Office Action Summary	Application No. 10/813,242	Applicant(s) SELLERS ET AL.	
	Examiner NAHID AMIRI	Art Unit 3679

DETAILED ACTION

Claims 1, 3-6 and 10 are rejected under 35 U.S.C. 103(a) as being unpatentable over US Patent No. 6,042,293 Maughan in view of US Patent No., 2,635,906 Graham et al.

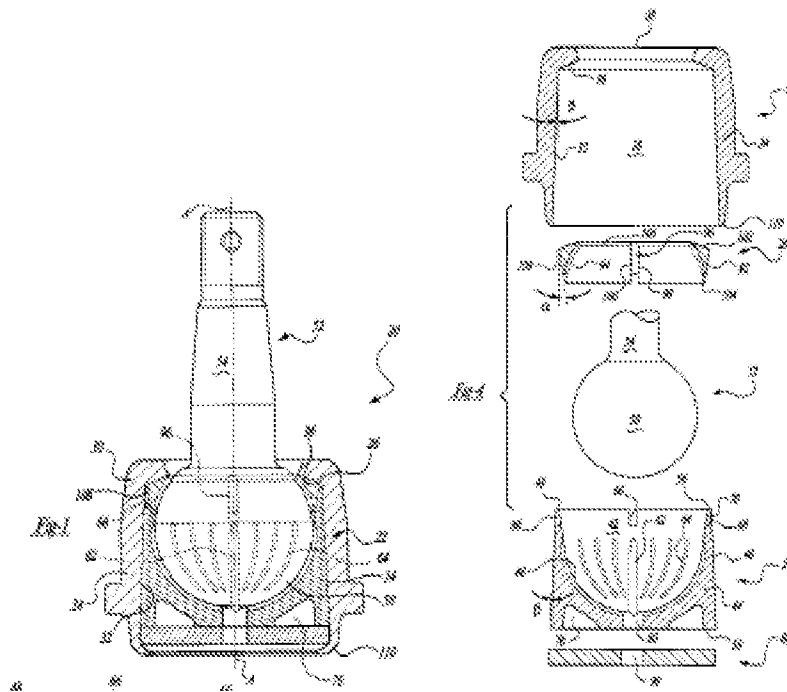
With respect to claims 1, 3 and 4, Maughan discloses a joint assembly (20, Figs. 1, 4) including a metal housing (30) having a side wall (34) which defines a central bore having a closed end via a washer (88) and an open end, the metal housing having an axial lubrication port

(90) in the closed end (88) of the central bore; a metal lower bearing (24, shown with a metal cross-hatching) disposed within the central bore adjacent the closed end, the metal lower bearing (24) including a lubrication slot (60) disposed on an inner bearing surface, the lubrication slot (60) being generally axially aligned with the central lubrication port (90) in the metal housing (30) to provide a common lubrication passageway; a metal moveable member (52) having a head end portion (50) disposed in the central bore and a shank portion (54) extending from the head end portion (50), the head end portion (50) engaging the central bore of the metal housing (30), the shank portion (54) being at least partially disposed outside of the central bore; an annular metal upper bearing (26) disposed about the movable member (52) within the central bore, the annular metal upper bearing (26) having an inner surface engaging the head end portion (50) in direct metal-to-metal sliding contact, and outer surface directly engaging the side wall (34), and a split segment (96) extending from the inner surface to the outer surface; and wherein the annular metal upper bearing (26) is configured to engage the side wall (34) and the head end portion (50) simultaneously. Maughan fails to disclose an annular cover plate disposed about the movable member and secured within the central bore; and a spring member compressed between the annular cover plate and an upper surface of the annular upper bearing; the annular cover plate and spring member are composed of metal, and wherein the spring member exerts an axial preload force on an annular metal upper bearing (constituted by an inner surface of the housing 10) with toward the closed end of the central bore, and a head end portion (12a) simultaneously. Graham et al. teach a ball joint (Fig. 2) that includes an annular cover plate (15) disposed about the movable member (12) and secured within the central bore; a spring member (14) compressed between the annular cover plate (15) and an upper surface of the annular upper bearing (13); the annular cover plate (15) and spring member (14) are composed of metal, and wherein the spring member (14) exerts an axial preload force on the annular metal upper bearing (13) toward the closed end of the central bore, and the head end portion (12a) simultaneously. It would have been obvious to one of ordinary skill in the art at the time of invention was made to provide the ball socket joint of Maughan with a metal cover plate and a metal spring as taught by Graham et al. in order to urge the bearing wall of the bearing ring to maintain it against the ball end of the stud.

253

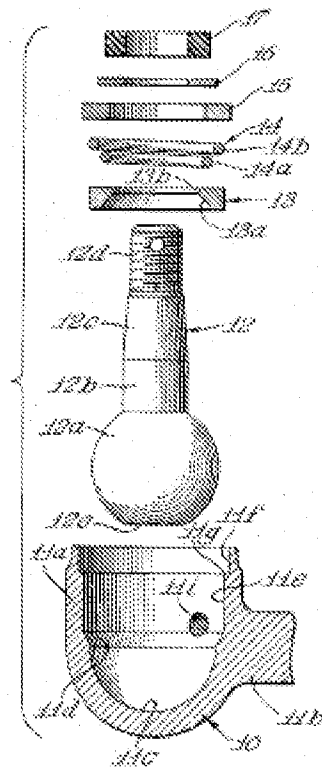
With respect to claim 10, Maughan fails to disclose that the housing includes a deformable annular region adjacent the open end of the central bore, the deformable annular region adapted for radially inward deformation to secure the annular cover plate within the central bore. Graham et al. disclose (Fig. 1) the housing (11) includes a deformable annular region (11j) adjacent the open end of the central bore, the deformable annular region adapted for radially inward deformation to secure the annular cover plate (15) within the central bore. It would have been obvious to one of ordinary skill in the art at the time of invention was made to provide the ball joint of Maughan with a cover plate having a deformable annular region adjacent the open end of the central bore as taught by Graham et al. in order to secure the cover plate into the housing.

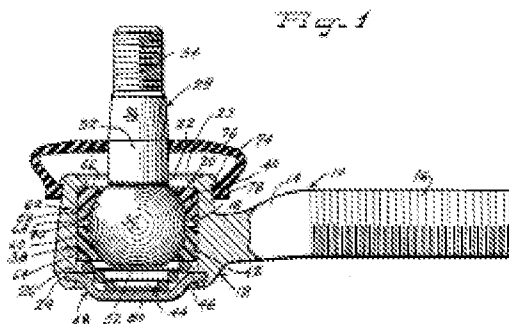
With respect to claim 7, Maughan and Graham et al. fail to disclose that the dust boot restrictor disposed about the shank portion. Herbenar teaches a ball joint (Fig. 1) having a dust boot (74). It would have been obvious to one of ordinary skill in the art at the time of invention was made to provide the ball joint of Maughan with a dust boot as taught by Herbenar in order to seal the open upper end of the housing

With respect to claim 8, Maughan and Graham et al. fail to disclose a flexible dust cover coupled between the housing and the shank portion of the movable member. Herbenar teaches (Fig. 1) a flexible dust cover (74) coupled between the housing (12) and the shank portion (32) of the movable member (28). It would have been obvious to one of ordinary skill in the art at the time of invention was made to provide the joint of Maughan with a dust cover as taught by Herbenar in order to seal the open upper end of the housing.
